Knocking Noise From Fuel Tank Area

Market USA

YEAR(S)	MODEL(S)	ADDITIONAL INFORMATION
2016 - 2019	RX350

Some 2016 – 2019 model year RX350 and 2018 – 2019 model year RX350L vehicles may exhibit a knocking noise from the fuel tank area at idle, vehicle stationary, with a full tank of gasoline. Follow the Repair Procedure in this bulletin to address this condition.

Figure 1. Without Pulsation Damper Valve Assembly Installed

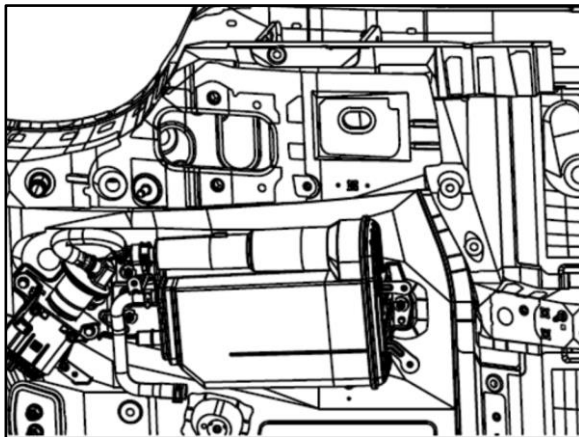
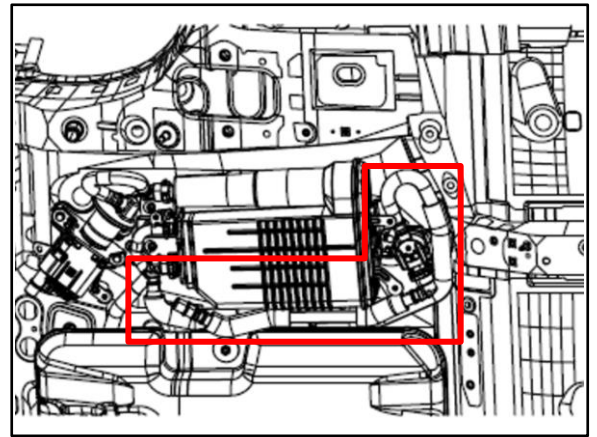
The NEW part can be identified by the addition of a bracket and valve assembly attached to the charcoal canister.

2. Confirm if the vehicle has the NEW pulsation damper valve assembly installed.

Figure 3.

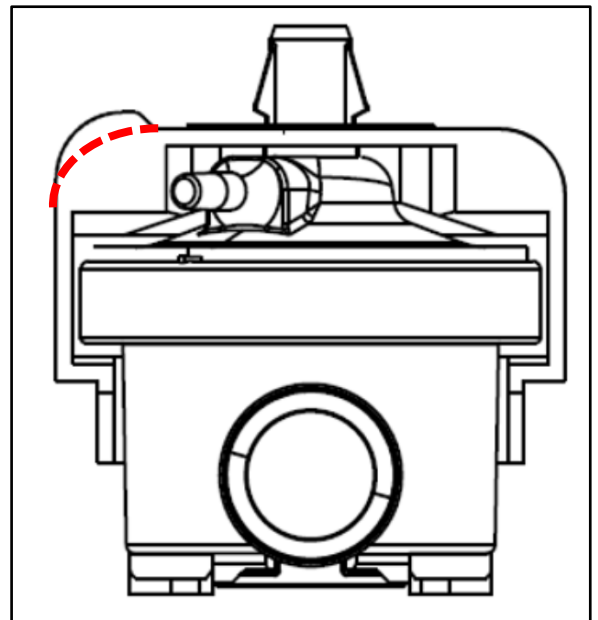
6. To provide adequate clearance to the NEW bracket, trim the NEW pulsation damper valve as shown.

Figure 4.

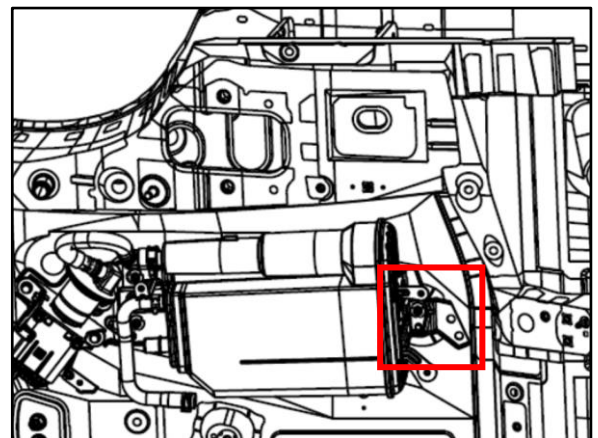
8. Install the NEW bracket to the charcoal canister.
 - A. Remove the nut from the front of the charcoal canister.
 - B. Install the bracket on the stud.
 - C. Tighten the nut and valve assembly plate into place.
Torque: 5.5 N*m (56 kgf*cm, 49 in*lbf)

Figure 5.

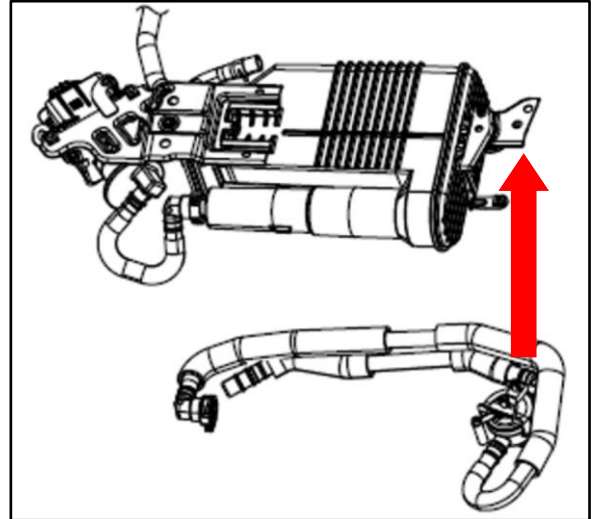
9. Install the NEW pulsation damper valve assembly onto the NEW bracket.
Push both retaining clips of valve assembly through the two holes on the bracket.

Figure 6.

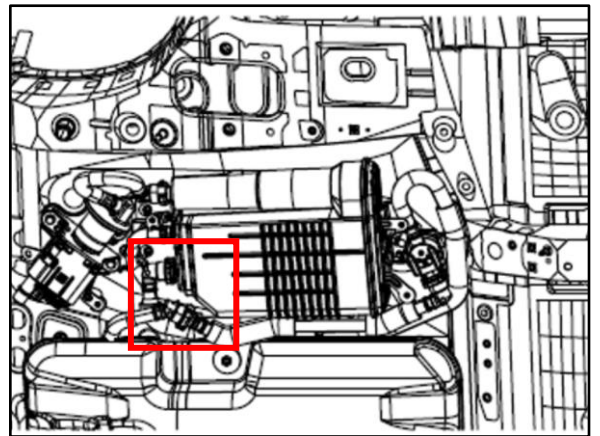
10. Connect the NEW pulsation damper valve assembly between the fuel tank vent hose assembly and the charcoal canister.

Figure 7.

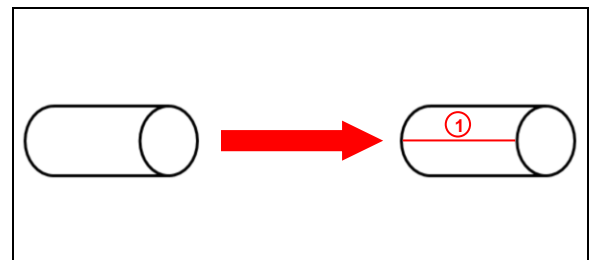
11. Cut the two reflect sleeves as shown.

Figure 8.

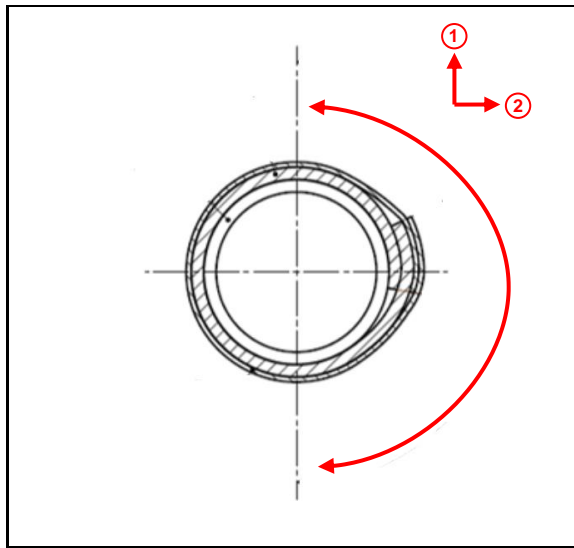
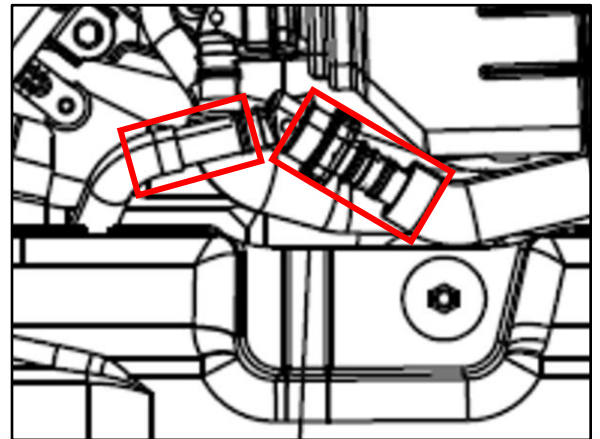
12. Wrap the two reflect sleeves around each of the vent tube connections and tape them into place as shown in Figures 8 and 9.

Figure 10. Zip-Tie Locations

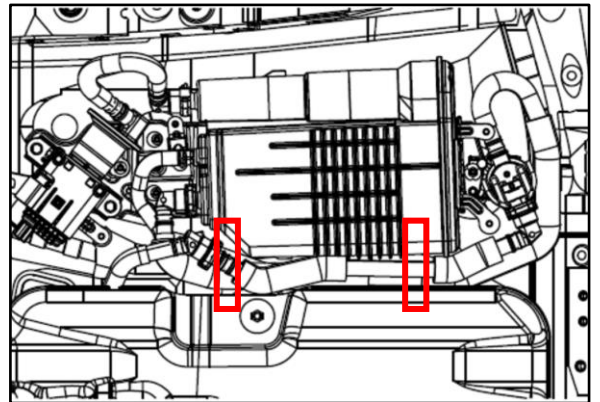
13. Using the zip ties supplied, tie the NEW pulsation damper valve assembly to the purge line as shown by doubling the zip ties together for each location.

Double or connect the zip ties to create enough length to secure the assembly.
